Intel[®] Mobile Celeron[™] Processor Specification Update

Release Date: October 1999

Order Number: 244444-008

Figure 2. Workaround Flowchart: SMBALERT#-Driven System

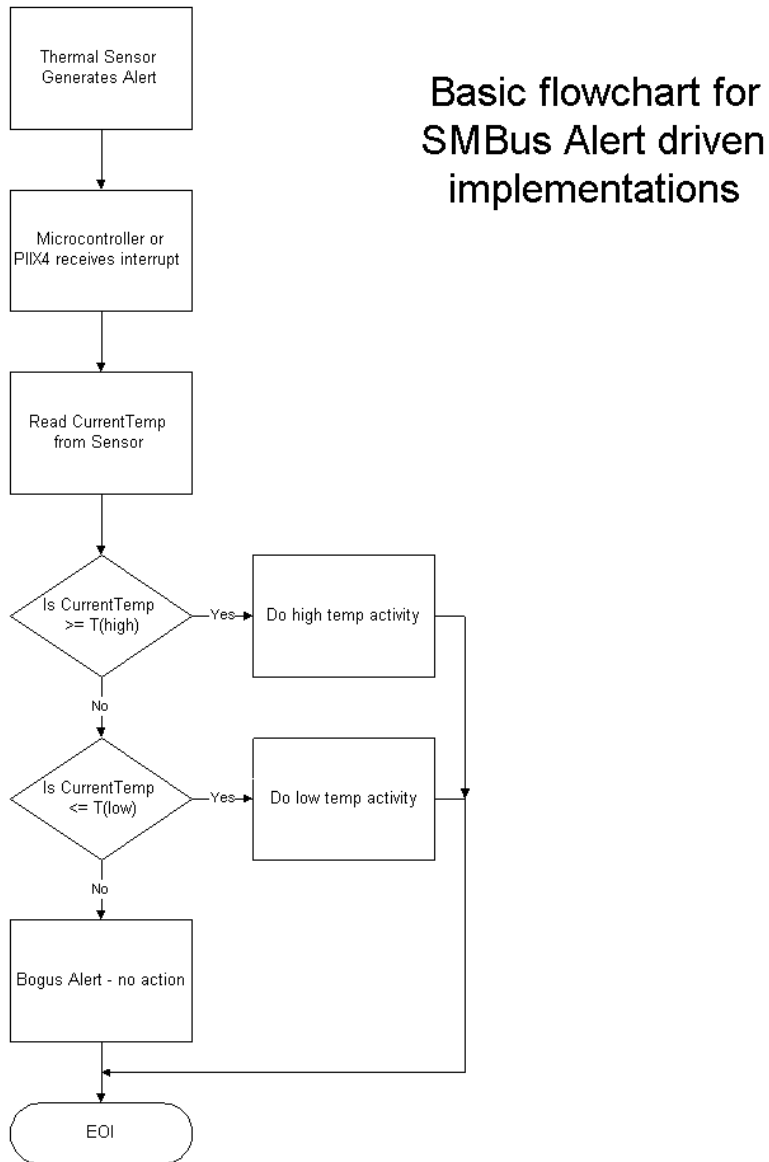
H29. Thermal Sensor May Assert SMBALERT# Incorrectly

Problem: The Intel Celeron Processor Mobile Module has a thermal sensor that monitors the processor core's temperature. Please note that desktop systems could have a similar thermal device. The thermal sensor asserts SMBALERT# if the processor temperature exceeds the temperature limits set in the Alarm Threshold Registers (T_{HIGH}, T_{LOW}). It also sets the corresponding Status Register bits to identify the cause of the interrupt. Figure 1 gives one example of the how the SMBALERT# signal could be used in a system.

Workaround: Three different (mutually exclusive) workarounds are possible:

1. Before servicing an interrupt from the thermal sensor, read and compare the processor thermal reading with the threshold limits (T_{HIGH} or T_{LOW}). Figures 2 and 3 provide basic flowcharts for the implementation of this workaround in an interrupt driven system.
2. If the firmware implemented polls the Status Register only, then before taking any action, re-read the temperature register and do a comparison with the alarm threshold limits (T_{HIGH} or T_{LOW}) to determine if the value is actually still within the temperature window.
3. Use a temperature polling scheme to monitor the processor temperature.

Figure 5.3. Surface-Mount BGA1 Package—Top and Side View

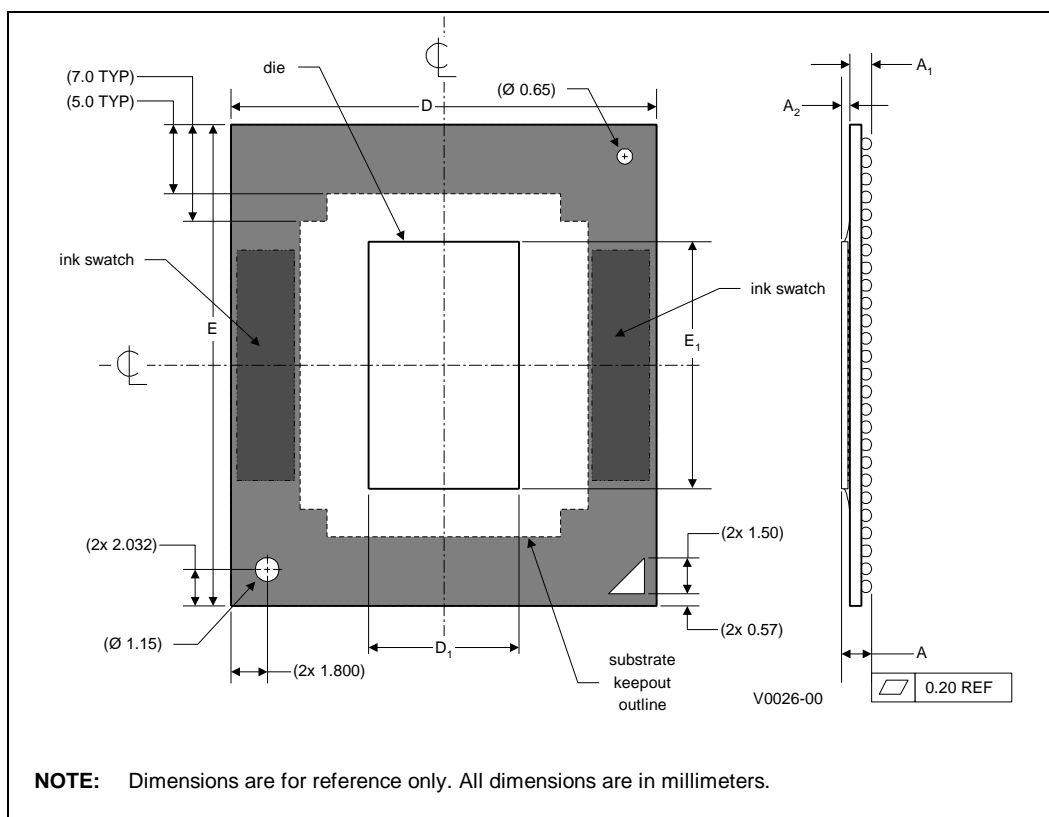
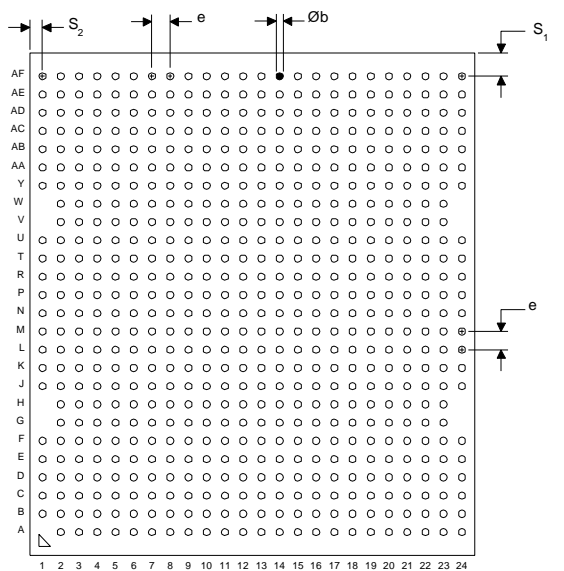
The following table and figures show the updated mechanical specifications for the BGA1 package, listed as Table 5.2, Figure 5.3 and 5.4, respectively, in the *Intel® Mobile Celeron™ Processor in BGA Package at 333 MHz, 300 MHz and 266 MHz* datasheet.

1. The number shown here is different from that in the 244444-004 version of this specification update. The maximum reference number is used.

Figure 3.3 Generic Clock Waveform

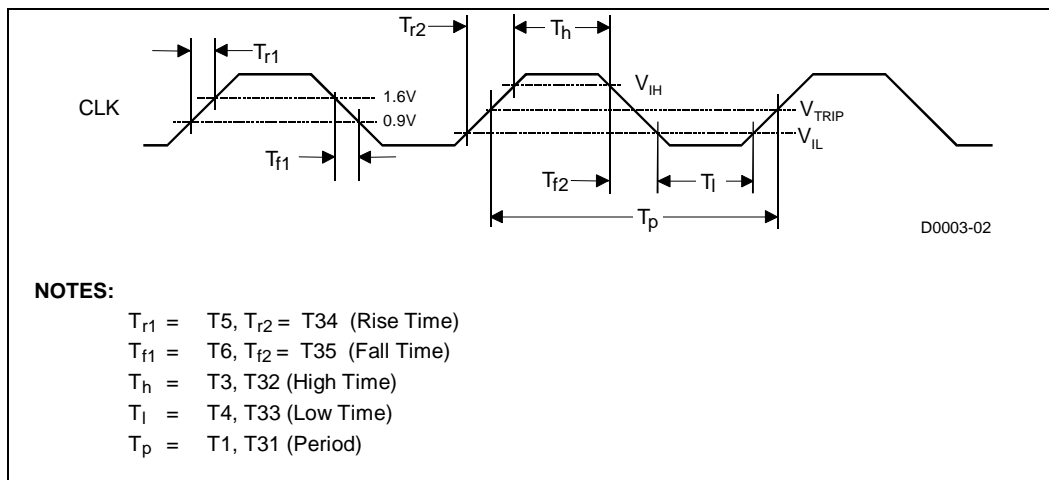
H11. Generic Clock Waveform Figure

Figure 3.3 in the *Intel® Mobile Celeron™ Processor in mPGA1 and BGA1 Packages at 366 MHz, 333 MHz, 300 MHz, and 266 MHz* datasheet (Order Number 245112-003) has been updated. The following figure is to replace the one in the above document.
